# Comparing Neighborhood Streets and Emergency Access

Teresa Jacobs -1/07/19

# Summary Data - Mary McCrea of Missoula Dvlpt Services / TLI's August 1 Hillside Comparable Report

## Visiting some South Hills' Neighborhoods with a measuring tape

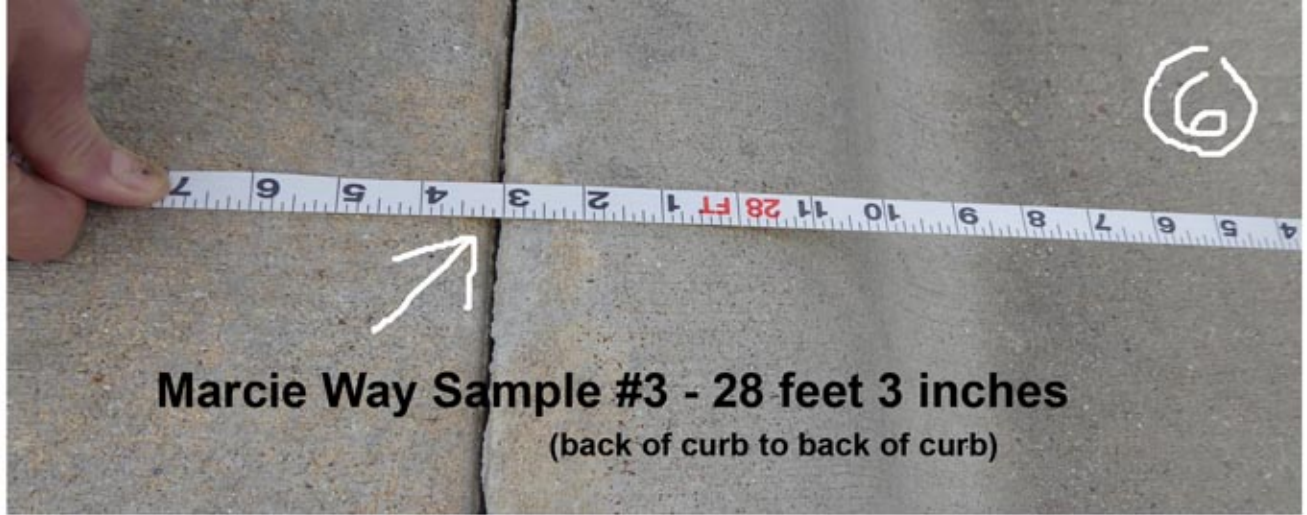
Measuring Macie Way on October 5th starting at the top, at its intersection with Colter. Our first sample was 29 feet wide exactly (back of curb to back of curb).

NOTE: Territorial-Landworks Inc stated that this street was 24.3 feet wide on page 5 of its 8/1/19 report. They also erroneously called Macie Way a cul-de-sac street, a drew false conclusions that Macie was narrower than proposed Hillview streets.

**Attachment C**

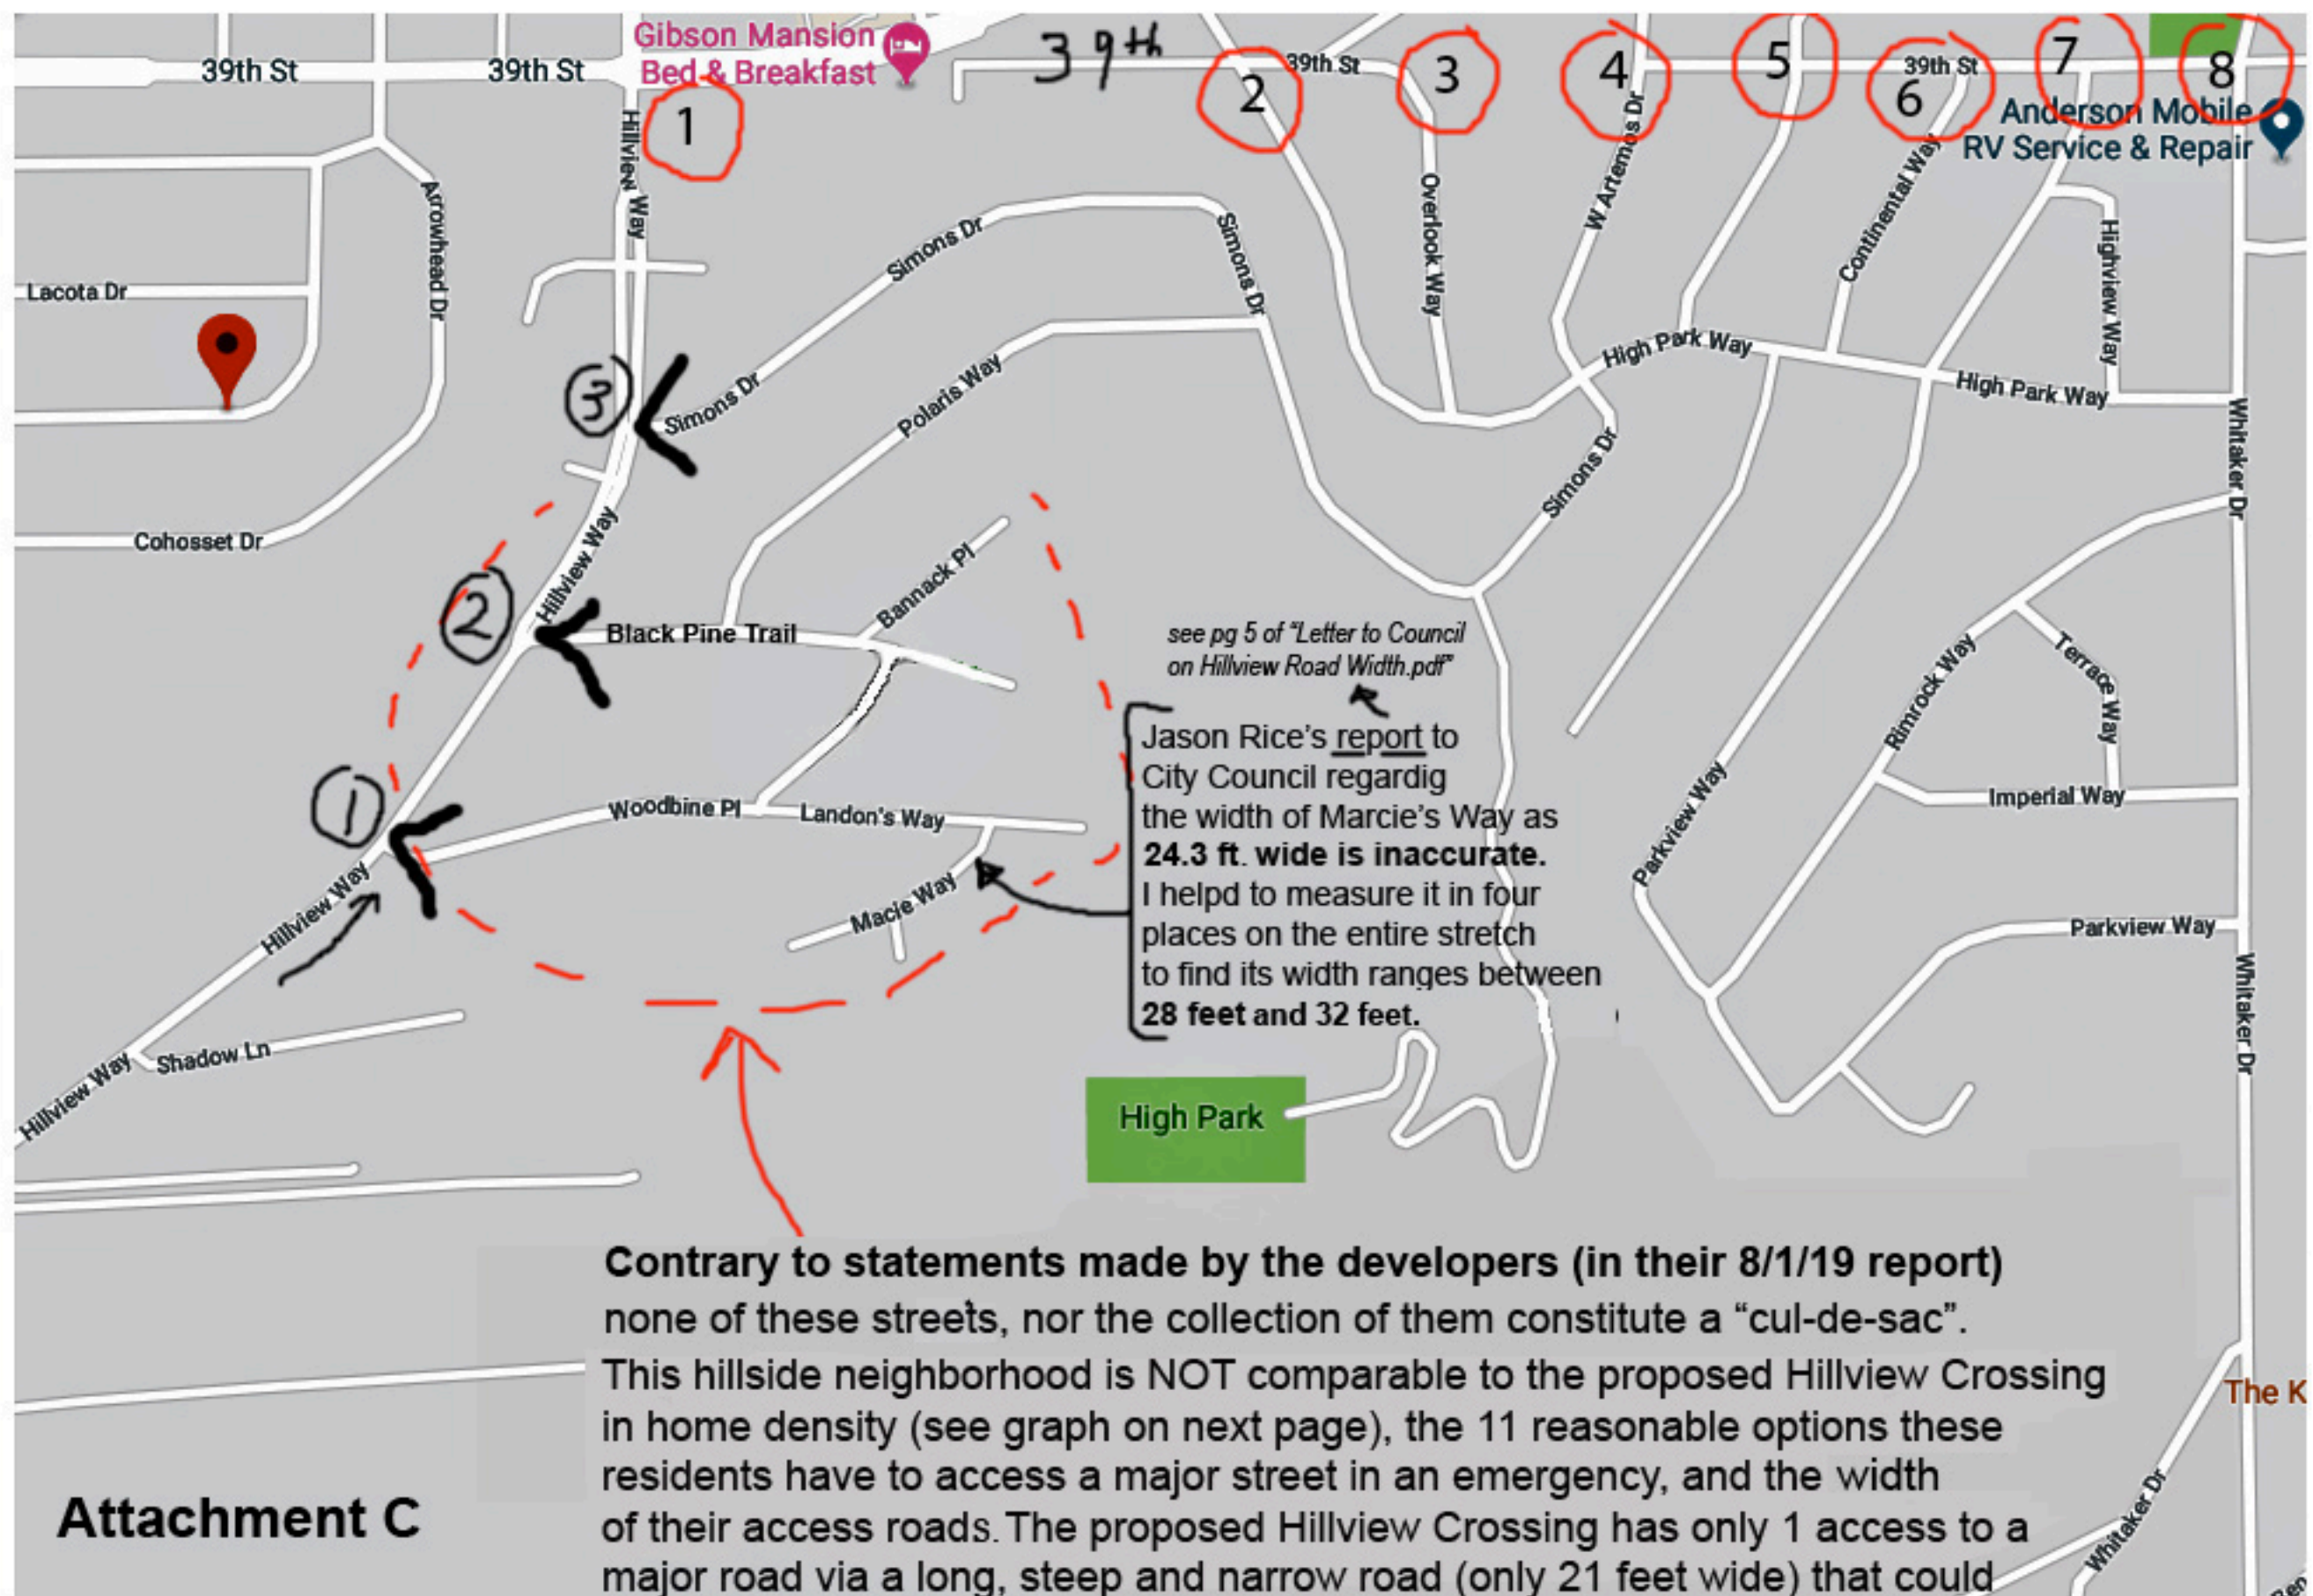
*Attachment C* This map shows how erroneous it was for the developers to refer to a local hillside neighborhood as cul-de-sac streets for purposes of trying to equate and justify their push for narrow streets. In actuality, these streets are part of a network that provides more than the 2 road access points to Hillview (that Mary McCrea pointed out on a small map during her Powerpoint slide on 8/14). **This expanded map how residents who live in these single family homes on uncrowded streets actually have 11 total routes to access major roads in an emergency.**

This map shows that residents in these single family homes located in the south hills actually have 2-3 routes for cars to get to and from Hillview and 8 routes to get to and from 39th Street in a pinch.
